**Paycor Stadium Southeast & Southwest VT Escalator Towers
Bid Package 2: Steel, Demo & Concrete
ITB#033-26
Addendum 3**

May 6, 2026

AD-103.4 1/8" = 1'-0"

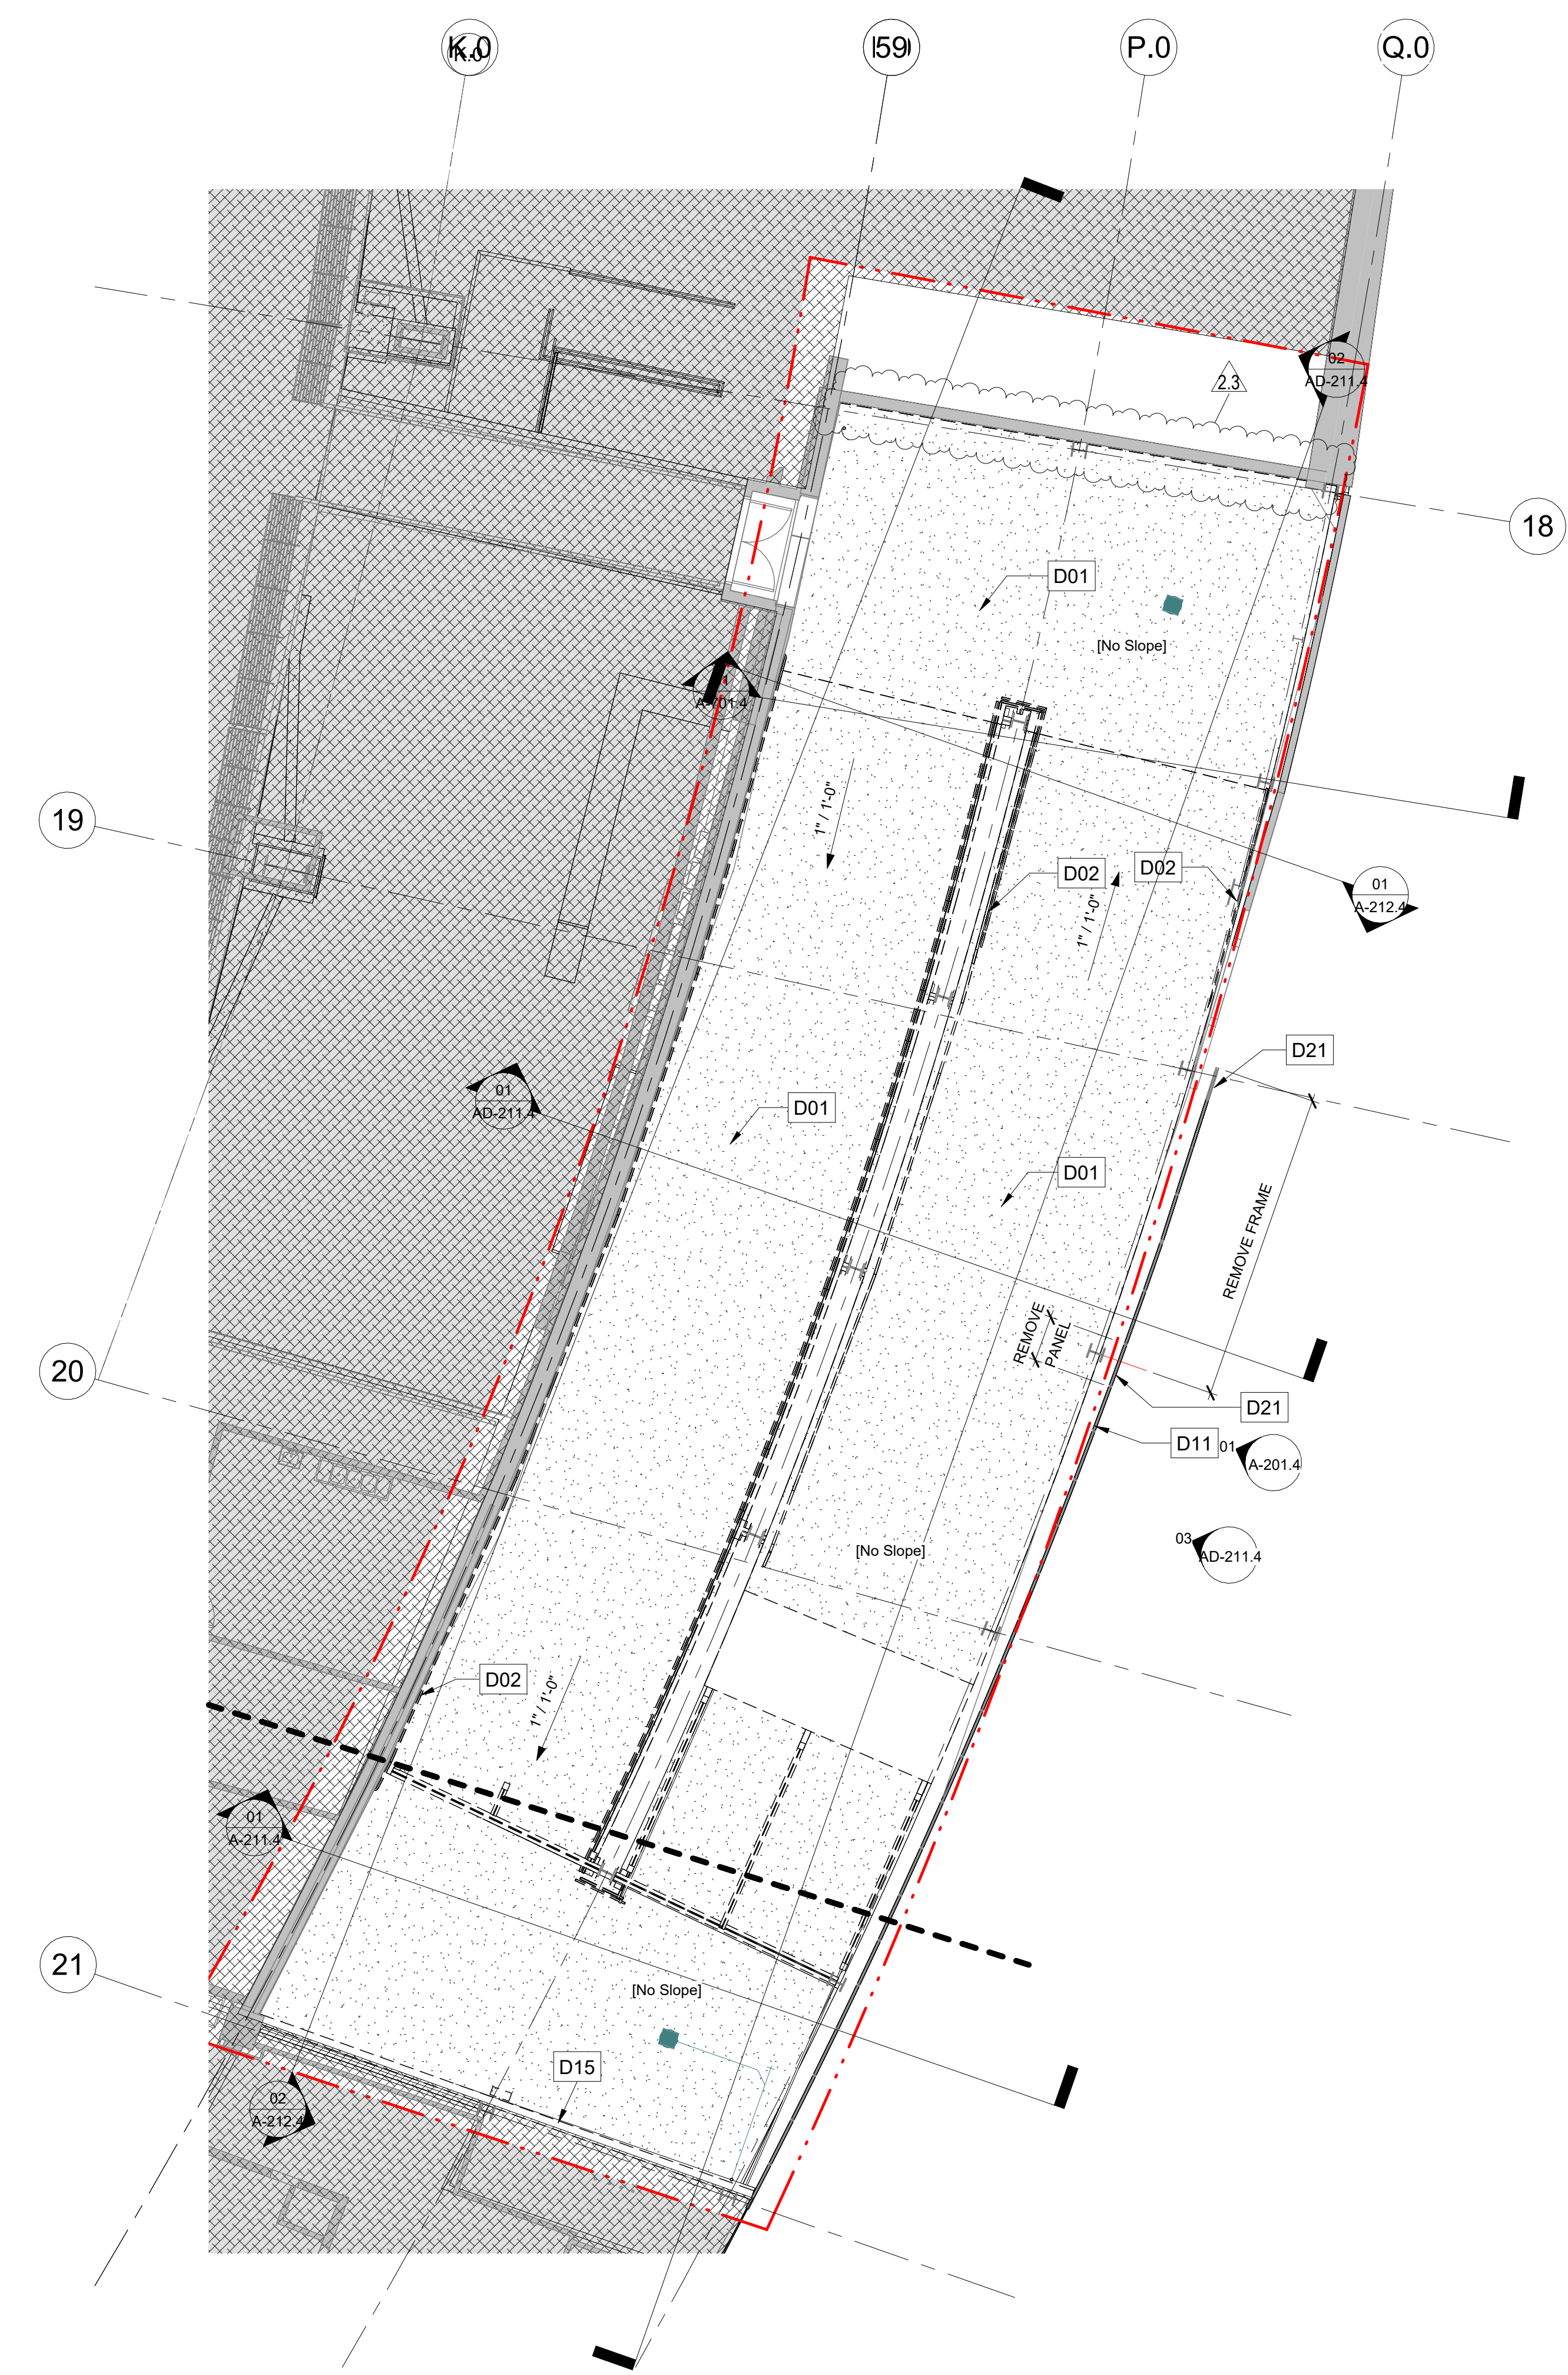
AD-101	New sheet with existing photos.
AD-103.4	Sector 4 – Level 400, 500 North wall to remain with limited demolition to remove existing Club stair.
AD-104.4	Sector 4 – Level 600 North wall to remain
AD-211.4	Sector 4 – Demolition Section & Elevation North wall to remain with limited demolition to remove existing Club stair.
S-103	Refer to sheet for clouded revisions
	Framing revisions
	S-104
	Refer to sheet for clouded revisions
	Framing revisions
S-105	Refer to sheet for clouded revisions
	Framing revisions
	Added section cuts
S-106	Refer to sheet for clouded revisions
	Framing revisions
S-108

SECTOR 9 - LEVEL 700 AND 750 FRAMING PLAN

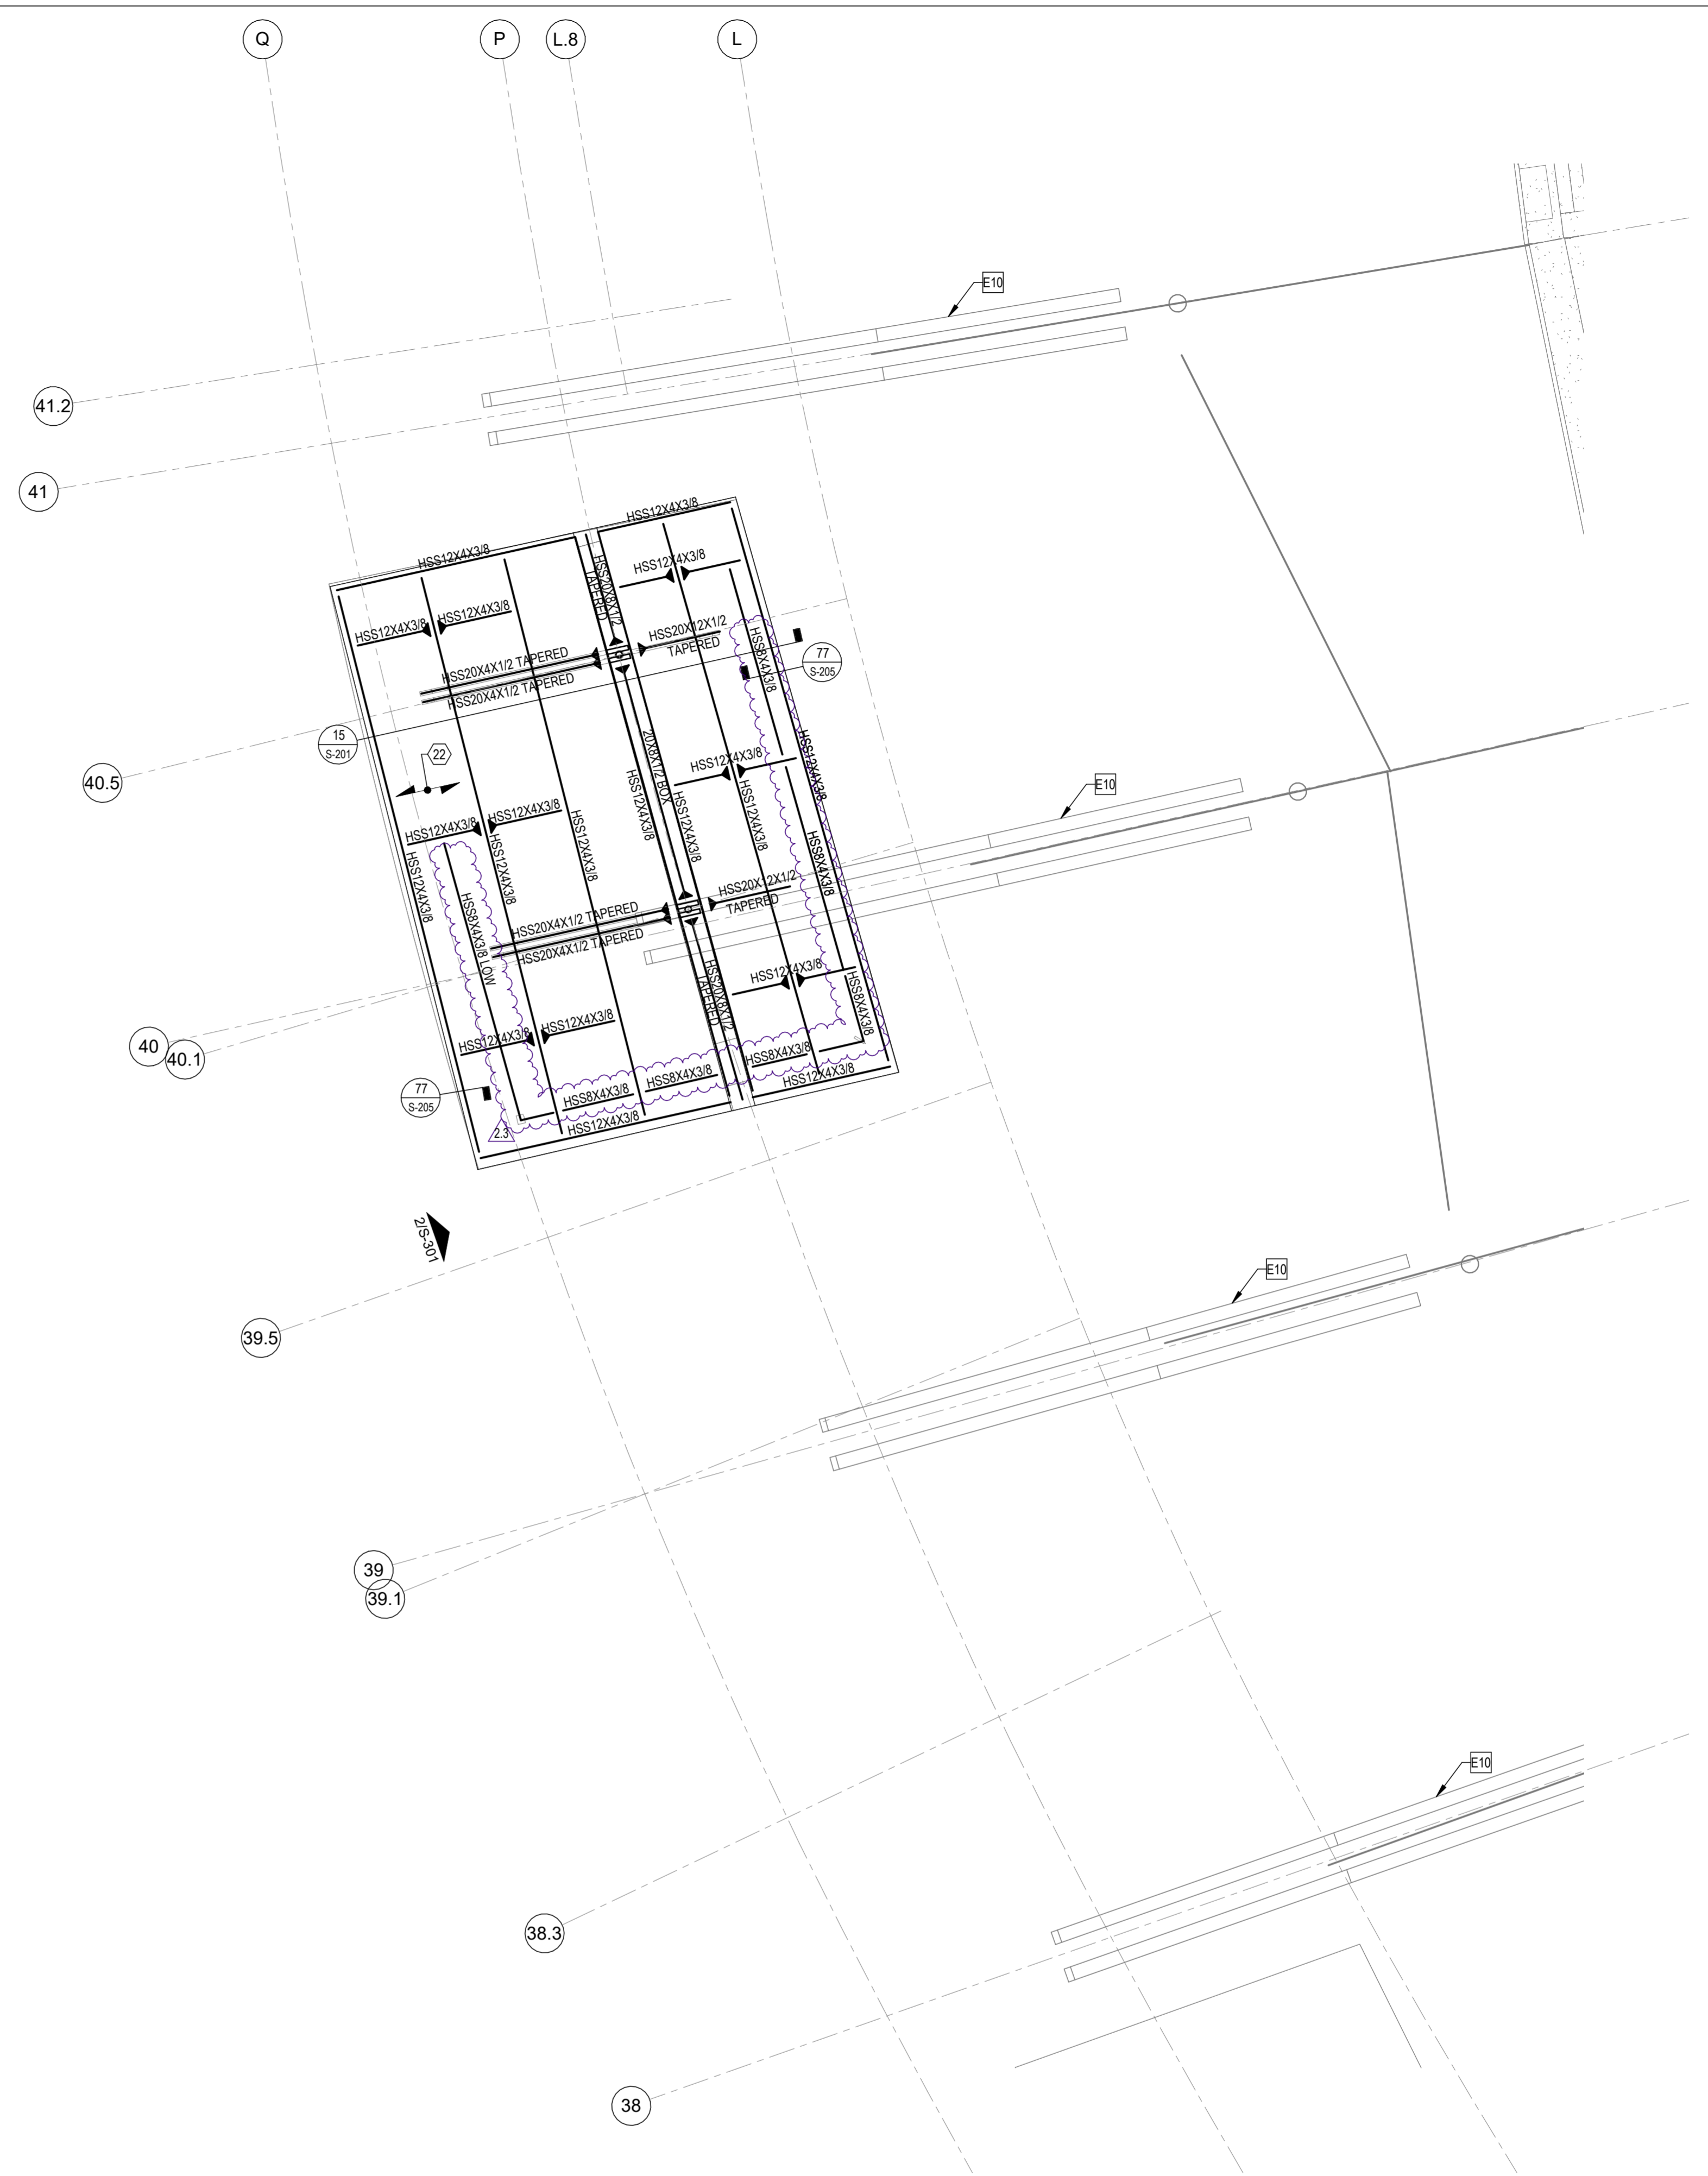
- S-109
 - Refer to sheet for clouded revisions
 - Framing revisions
- S-201
 - Refer to sheet for clouded revisions
 - Framing revisions
 - Added section cuts
- S-203
 - Refer to sheet for clouded revisions
 - Updated details for clarification
- S-204
 - Refer to sheet for clouded revisions
 - Updated details for clarification
- S-205
 - New Sheet - Refer to sheet for clouded revisions
 - Added section 79 thru 81

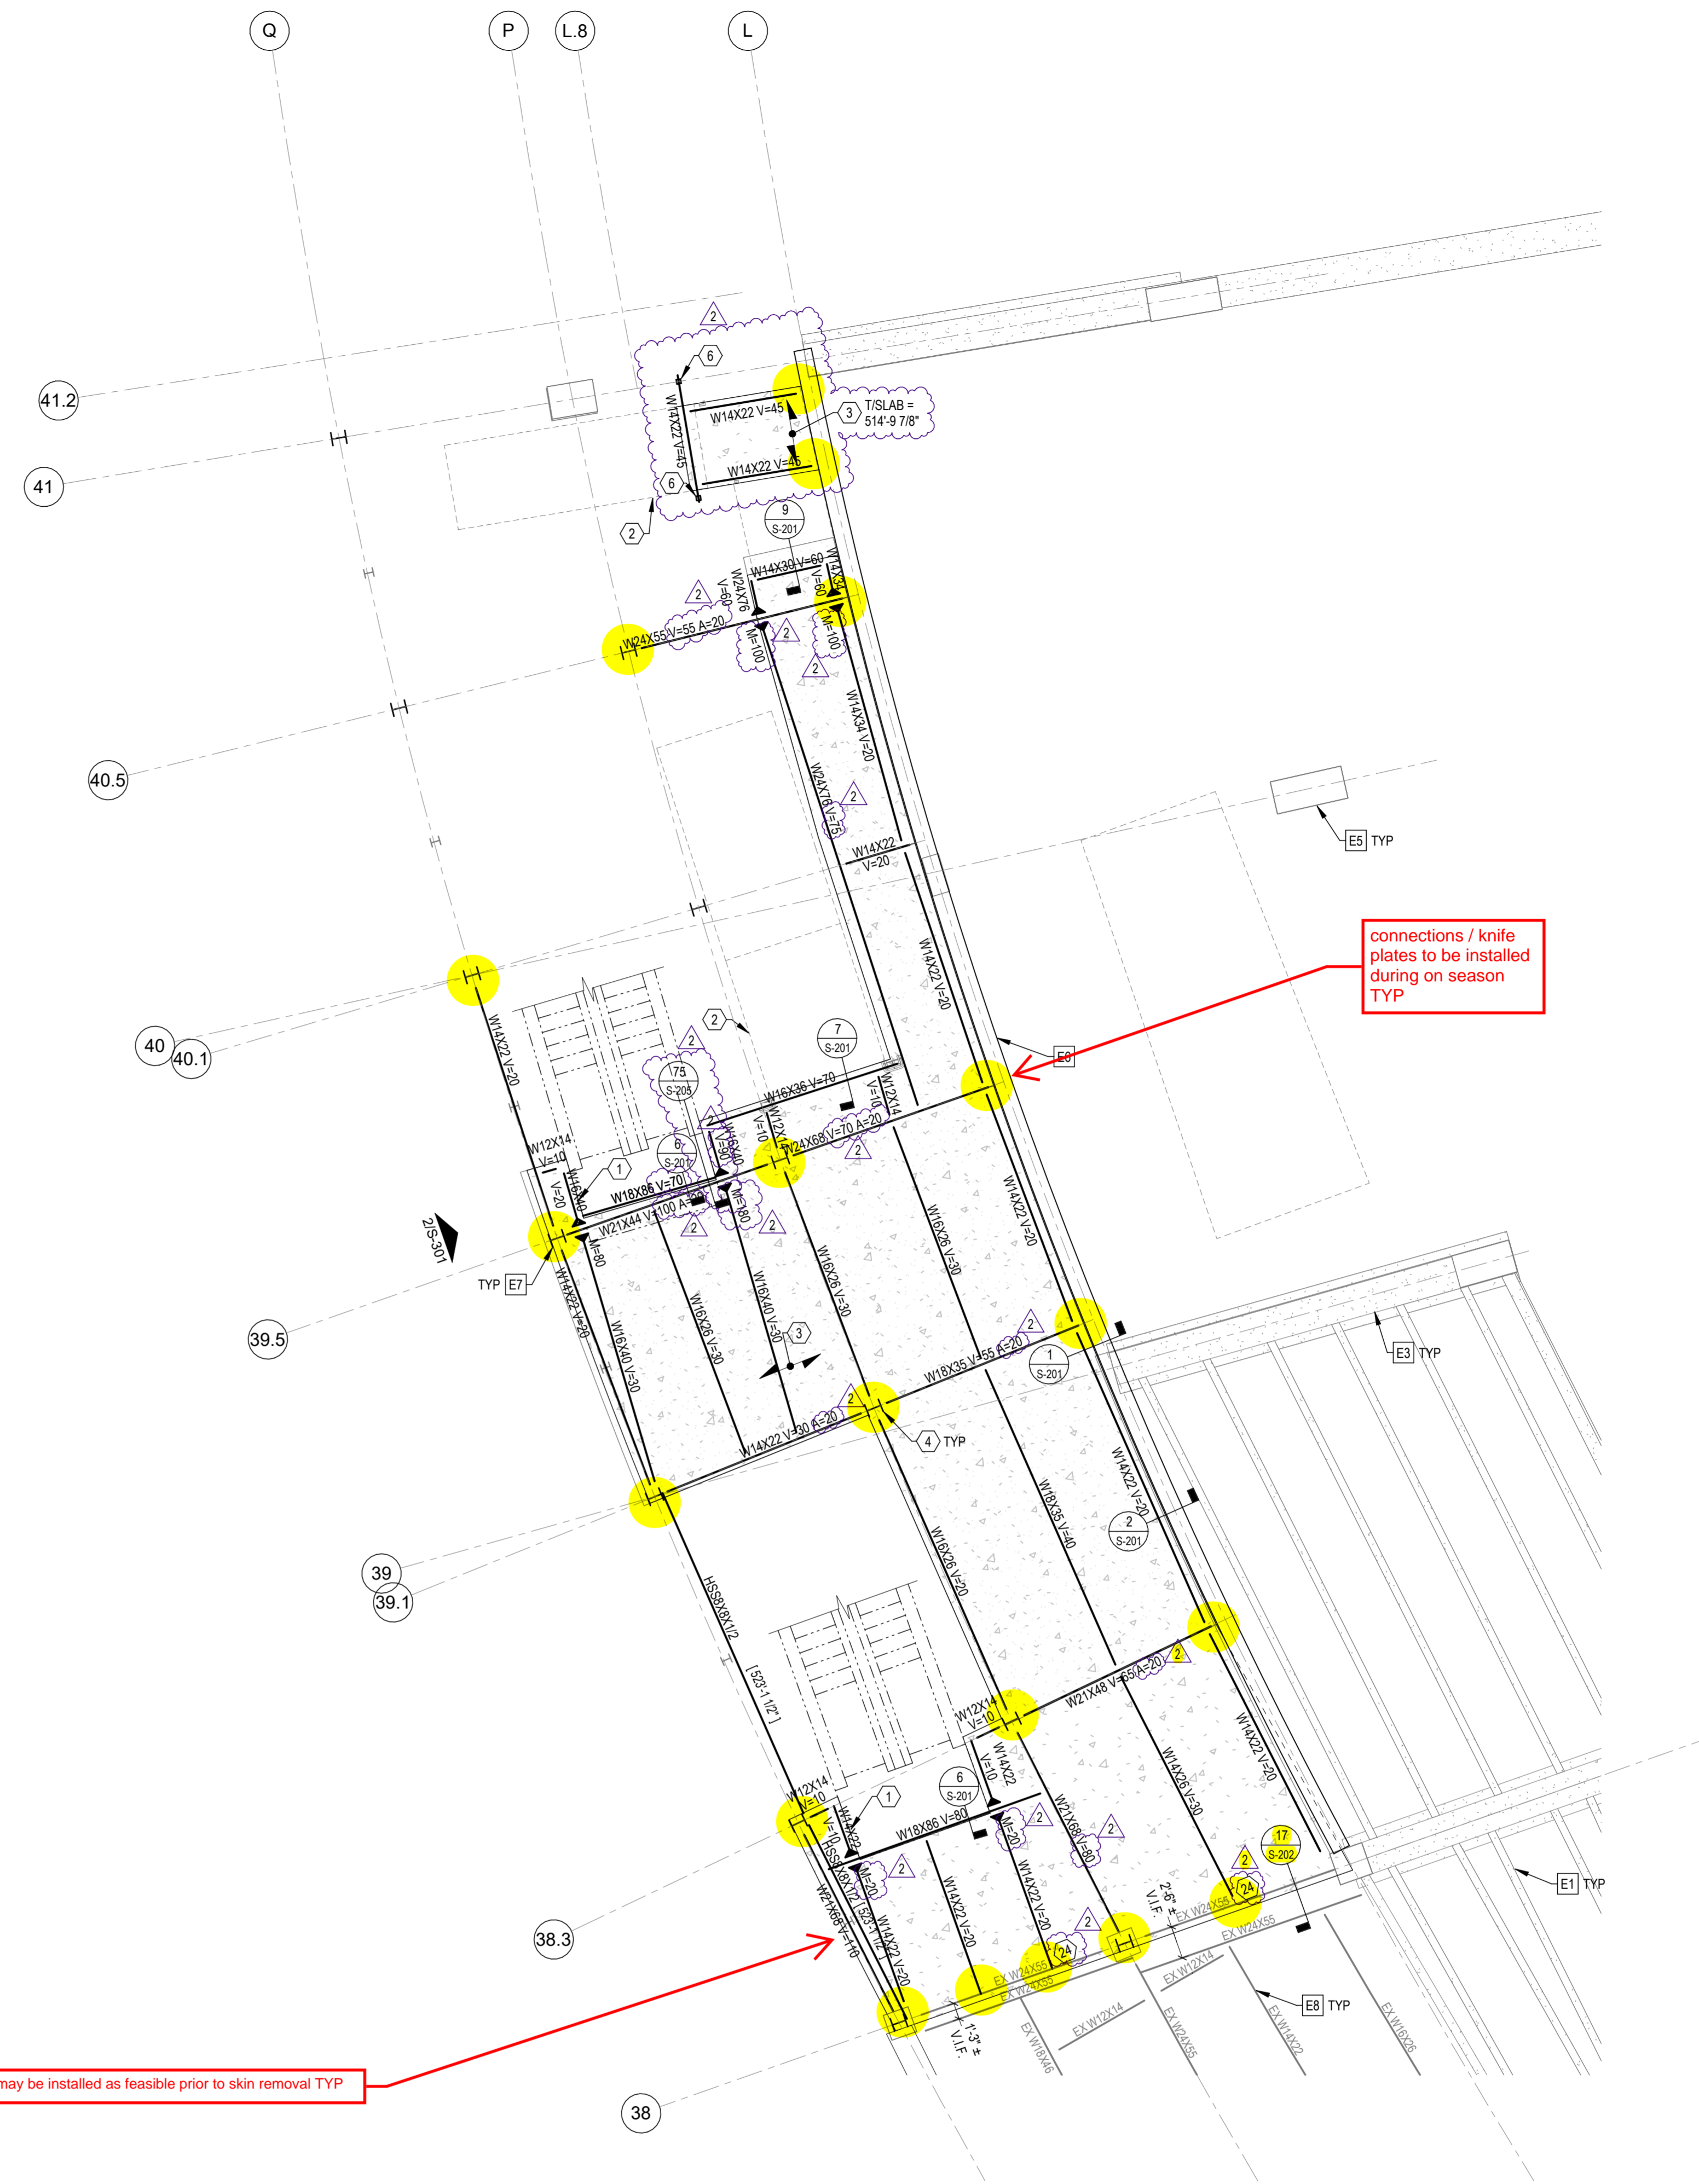
STL contractor to provide shoring of beams

connections / knife plates to be installed during on season TYP

connections / knife plates to be installed during on season TYP
